## Product Change Notice

Introduction of new lead frame source

ASCB-RTC2-0A207  
ASCB-RTCC-0A207  
ASCB-JTC2-0A208  
ASCB-JTC2-0A308  
ASCB-RTF2-0A207  
ASCB-RTF2-0A307

Part numbers : ASCB-RTC2-xxxxx/ASCB-RTCC-xxxxx

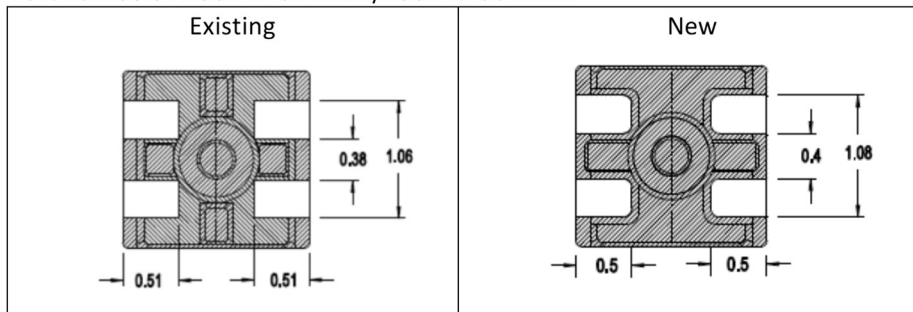
Change of new lead frame source with minor change of bottom view appearance and soldering terminal dimension.

There is a change of fit and form but no change in function, quality and reliability of the final product. The new and existing appearance as per below:
